Subject: Engineering, Procurement and Construction (EPC) Contract for Renovation and Modernization of Existing Navigational Lock at Farakka, West Bengal.

Reference: IN-IWAI-350002-CW-RFB-2

Amendment-5

Amendment triggered due to pre-bid responses:

PLAN

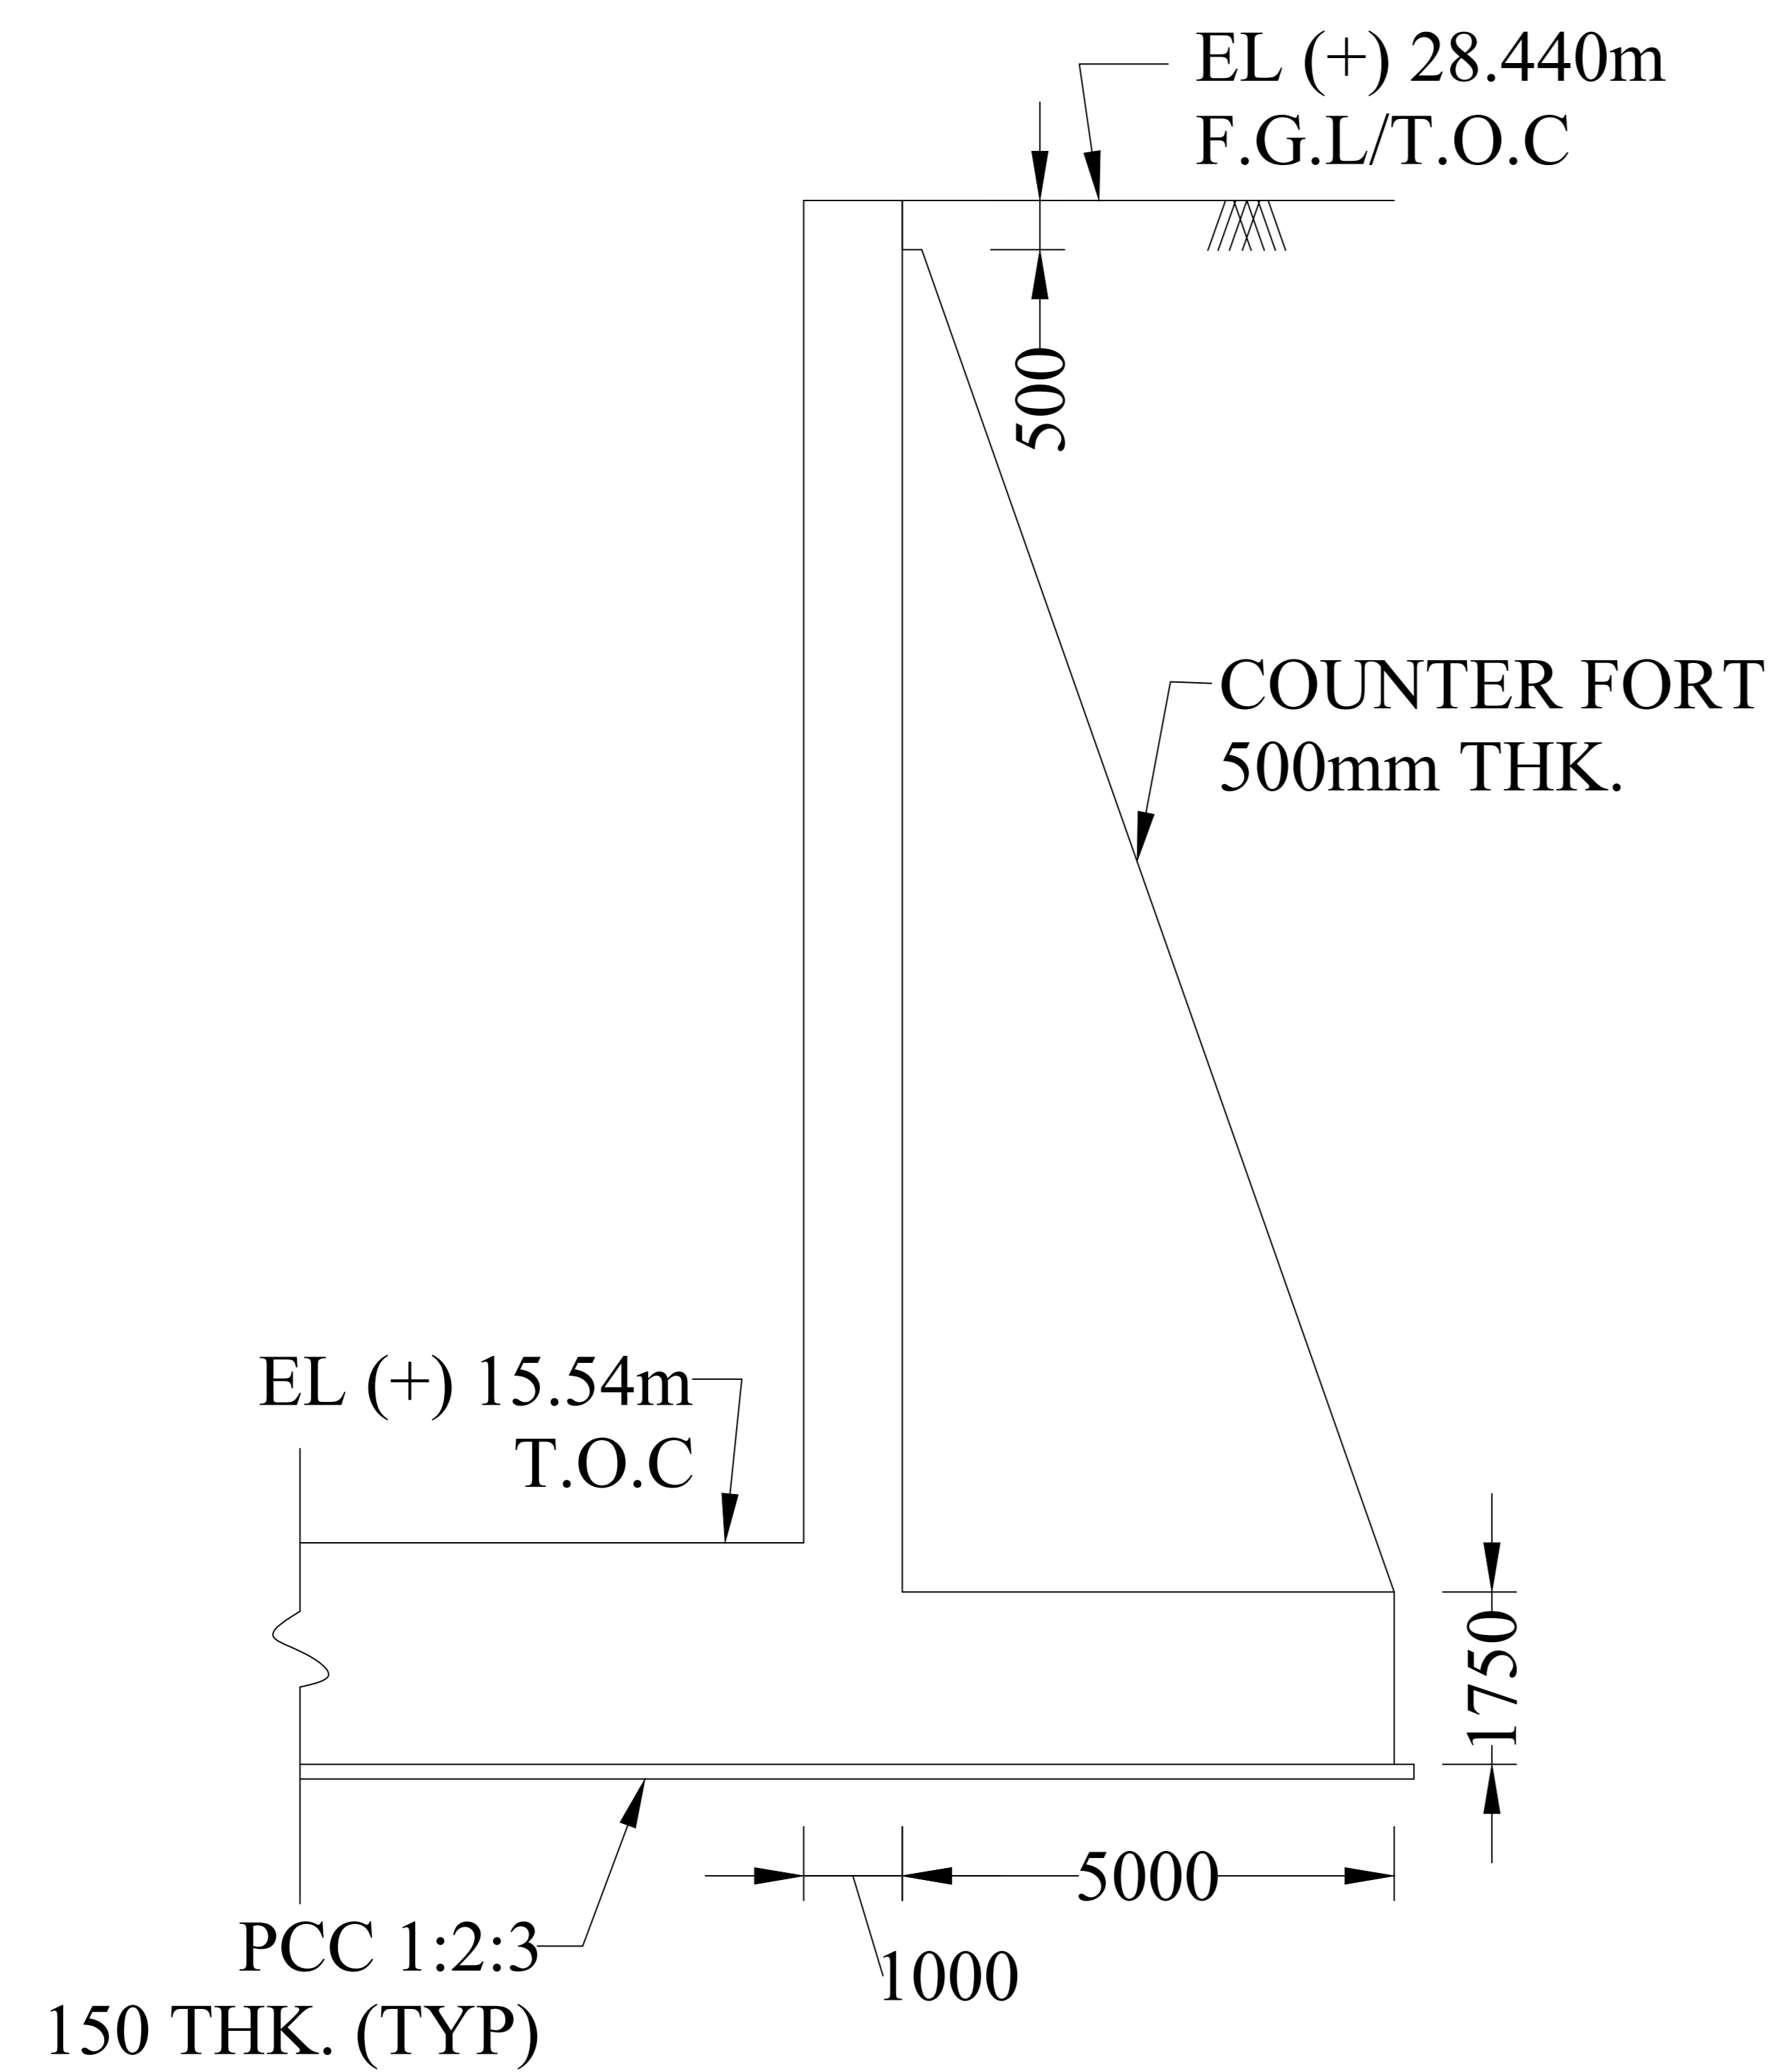
30	Drawing No. ENL-003, Vol-2, BoQ item no 7 & clause no 2.5.3 of Vol-3 at page no 12	<p>Control Rooms</p> <p>Engineering, Procurement and Construction of Control Room Building including local control rooms (2 Nos)</p> <p>Control Room Building Renovation and modernization of existing main control room building along with local control rooms (2 Nos) including mobilization & de-mobilization as per approved designs, drawings and specifications including testing, inspection and defect rectifications, complete in all respects.</p>	<p>BoQ item no 7 & clause no 2.5.3 of Vol-3 at page no 12 may be read as:</p> <p>Engineering, Procurement and Construction of Control Room Building including local control rooms (4 Nos)</p> <p>Control Room Building Renovation and modernization of existing main control room building along with local control rooms (4 Nos) including mobilization & de-mobilization as per approved designs, drawings and specifications including testing, inspection and defect rectifications, complete in all respects.</p>

JOB. NO.	DRG. NO.
	ENL011

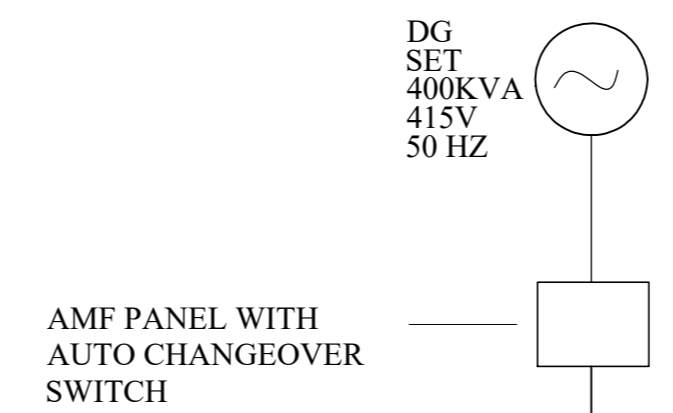
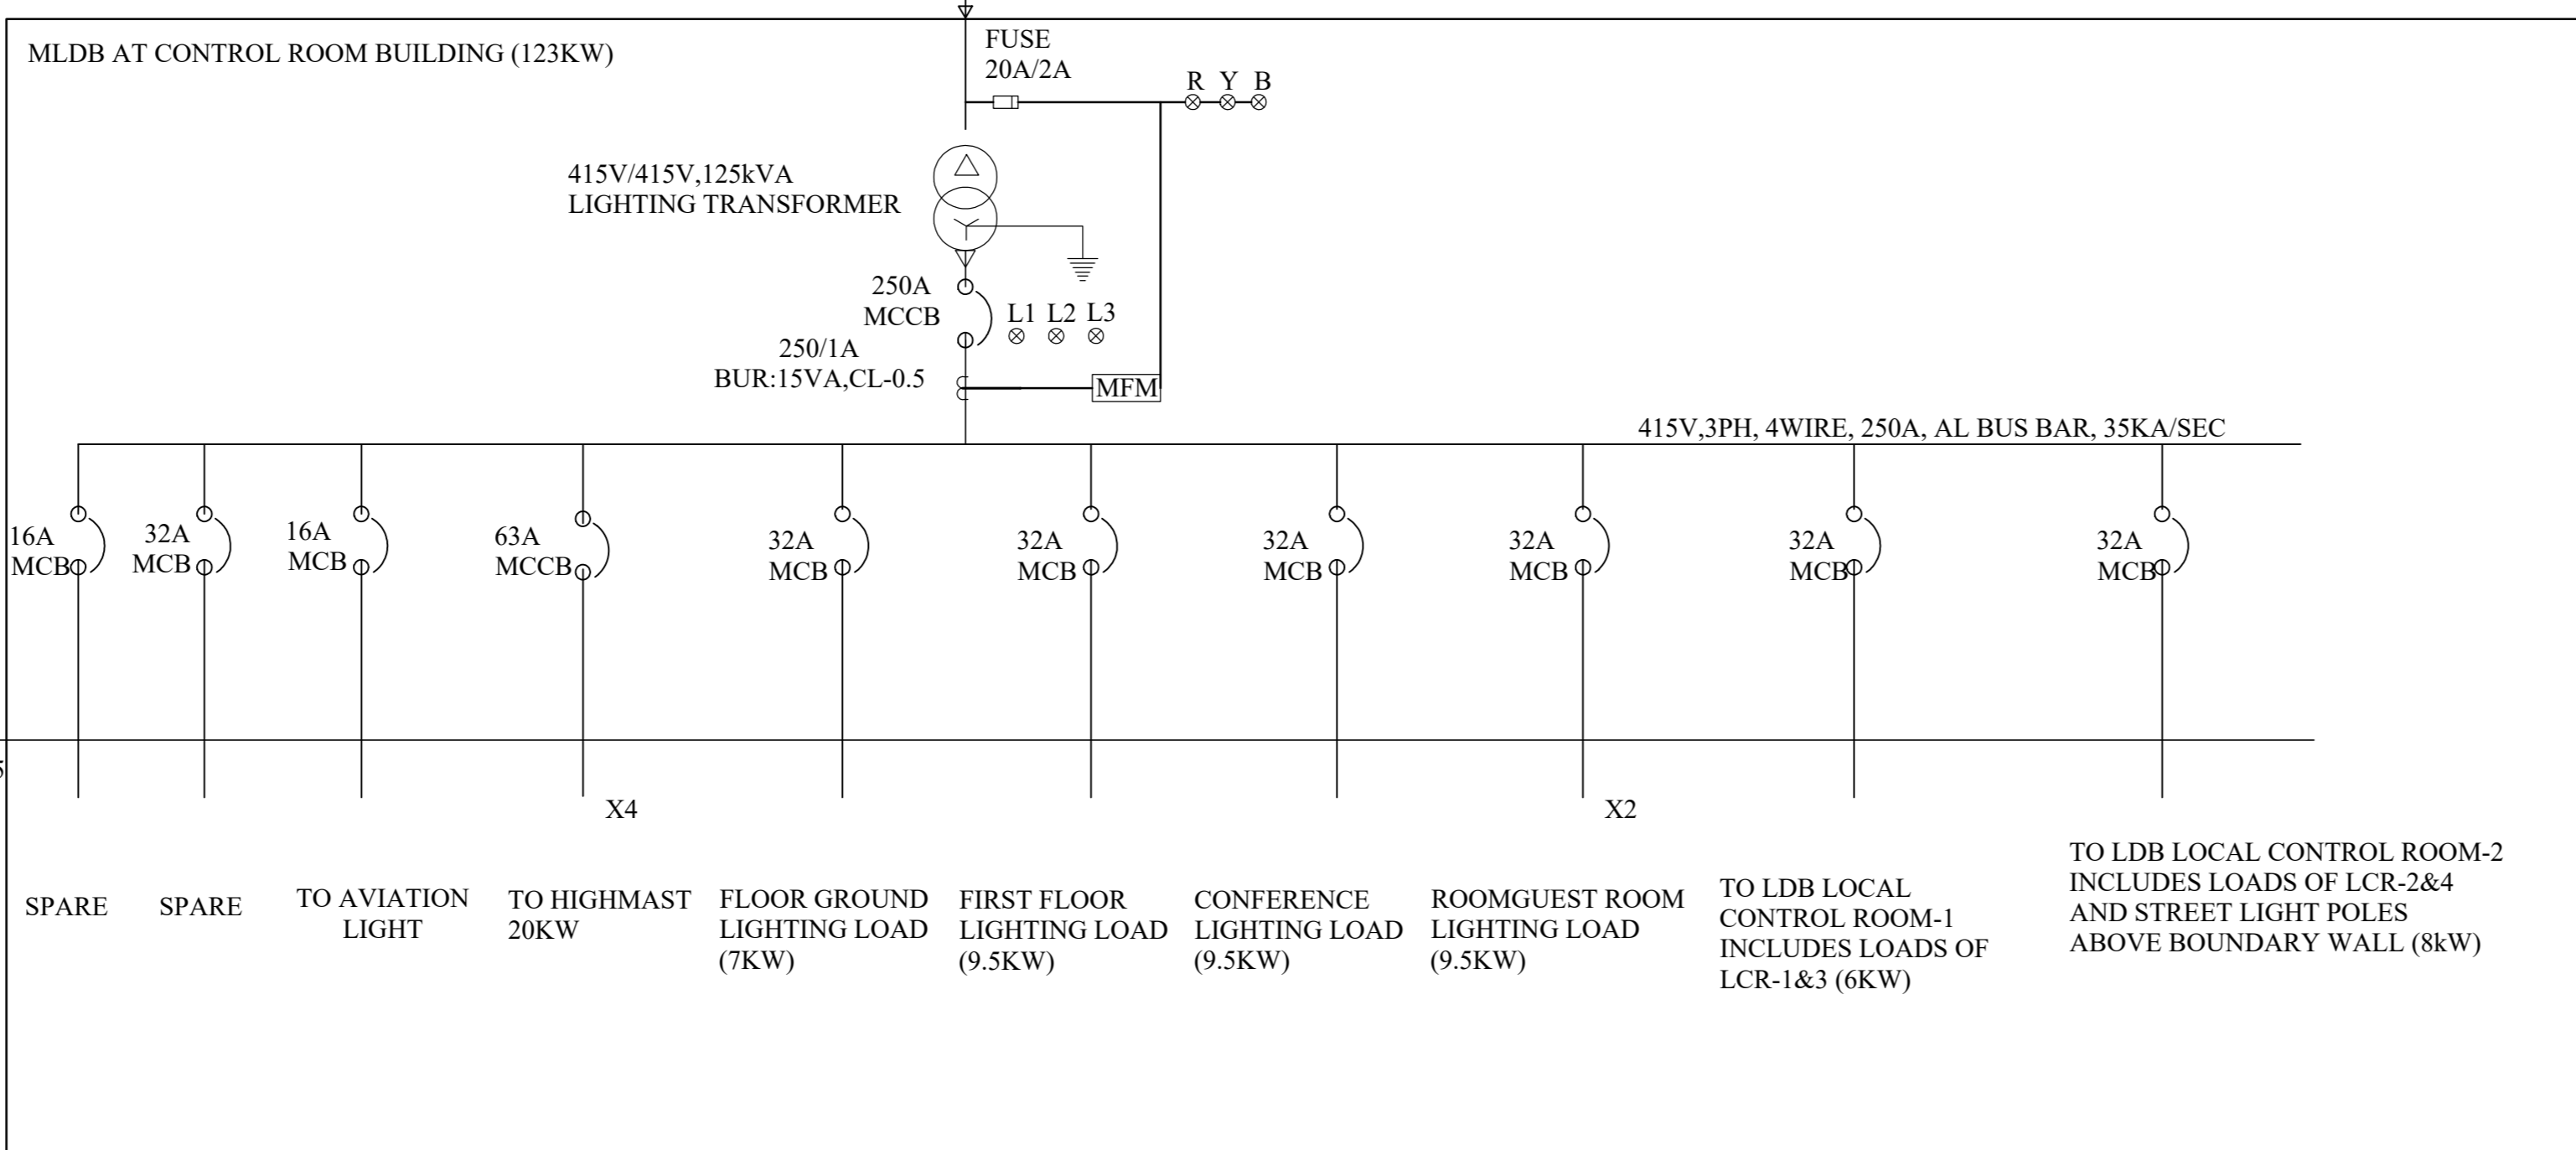
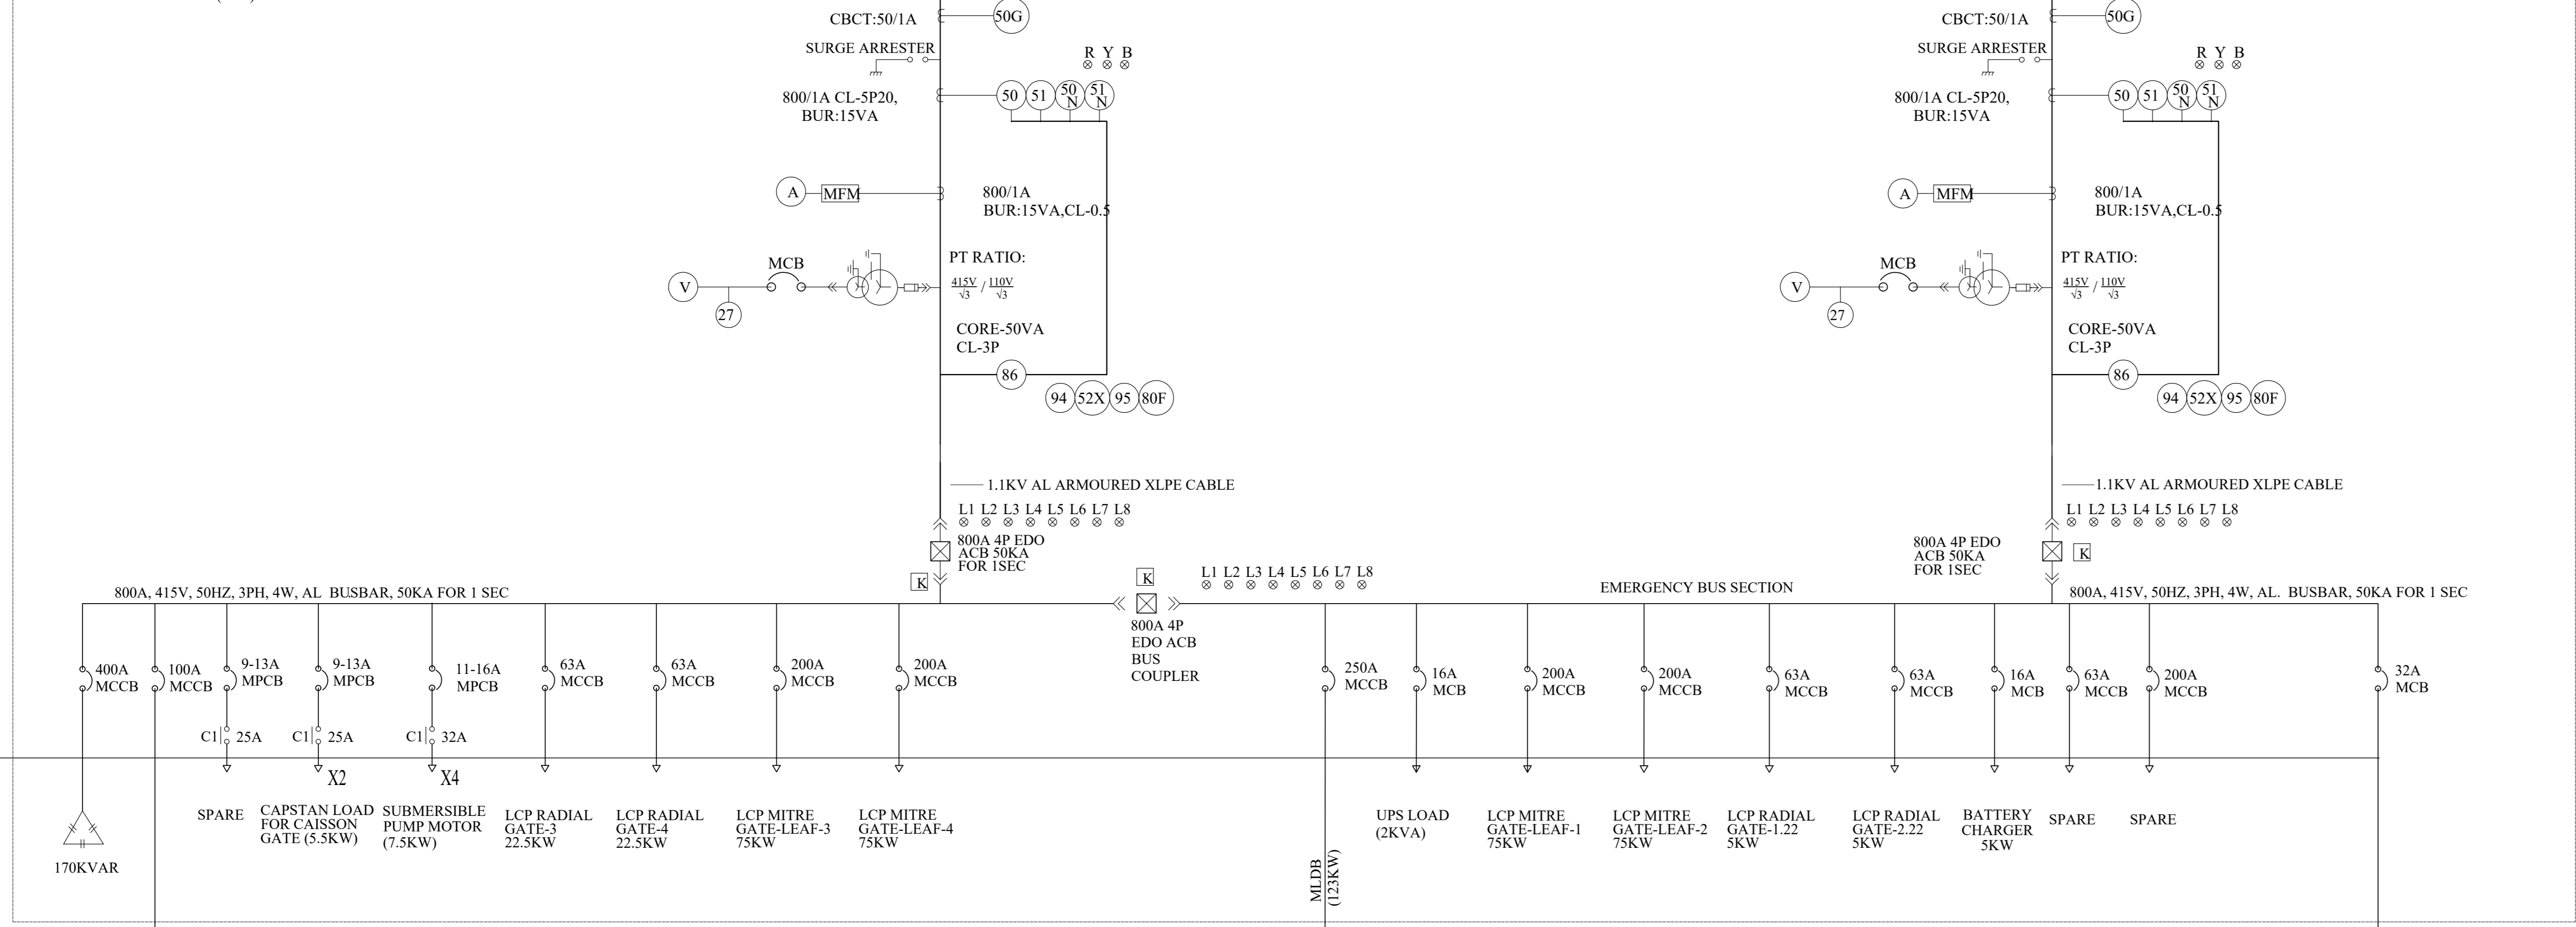
17	Volume II, 6.3 CAISSON GATE, 6.3.1 Structure, pg 531 of 571	Sill and side walls at gate grooves should be made of polished granite as per IS codes 14223 (Part-I) as mentioned in Design Criteria	Clause no 6.3.1 Fixing Arrangements at pg no 531 of 571 of Vol-2 may be read as: “Sill and side walls at gate grooves should be made of stainless steel as per relevant IS codes as mentioned in Design Criteria”.
18	Volume II: Technical Specifications, Volume - 2 Clause no 2.3.9 pg 81 of 571	Floataion and Stability – Caisson Gate, The gate shall be capable of being ballasted for de-ballasted in 30 minutes or less.	Clause no 2.3.9 at page no 81 of Vol-2 may be read as: “Floataion and Stability – Caisson Gate: the gate shall be capable of being ballasted or de-ballasted in 30 minutes or less.”
19	"POWER SINGLE LINE DIAGRAM OF EXISTING NAVIGATION	Local Control Room	The modified SLD (ENL 011_R1) attached at Annexure-A for indicative purpose. However, the contractor shall design the SLD. There are 1 Central Control Room and 4 local control room.

LOCK, FARAKKA (DRG. No: ENL011)" ELECTRICAL, Note no.15 & 16		
20	Electrical "Clause: 5.2.5.2, 110VDC System - Construction of Battery Charger cum DCDB", pg 422 of 571	Construction of Battery Charger cum DCDB: ".....Suitable synthetic rubber gaskets shall be provided to achieve a degree of protection of IP54....."	Clause: 5.2.5.2, 110VDC System - Construction of Battery Charger cum DCDB", page no 422 of 571 may be read as: ".....Suitable synthetic rubber gaskets shall be provided to achieve a degree of protection of IP42....."
21	Electrical "Clause: 5.2.5.1, 110VDC System - Construction of Battery" pg 421 & 422 of 571	Construction of Battery:Following accessories shall be provided with batteries. • Syringe type Hydrometer : 2 Nos per Battery • Thermometer with specific gravity correction scale: 2 Nos per Battery • Cell testing voltmeter 3-0-3 volts : 2 Nos per Battery • Acid resistant funnel : 2 Nos per Battery • Acid resistant jug. : 2 Nos per Battery • Rubber apron and gloves : 2 sets per Battery • Spanners : 2 sets per Battery • Wall mounted teak wood rack for above items : 2 Nos per Battery Following maintenance spares shall be provided as a minimum: • Inter cell connectors : 10 Nos. • Inter row connectors : 2 Nos. • Battery stand insulators : 2 Nos	Clause: 5.2.5.1, 110VDC System - Construction of Battery" pg 421 & 422 of 571 of Vol-2 may be read as: Construction of Battery:Following accessories shall be provided with batteries. • Cell testing voltmeter 3-0-3 volts : 2 Nos per Battery • Rubber apron and gloves : 2 sets per Battery • Spanners : 2 sets per Battery • Wall mounted teak wood rack for above items : 2 Nos per Battery Following maintenance spares shall be provided as a minimum: • Inter cell connectors : 10 Nos. • Inter row connectors : 2 Nos. • Nuts, bolts & washers : 10 pieces each • Vent plugs : 10 Nos.
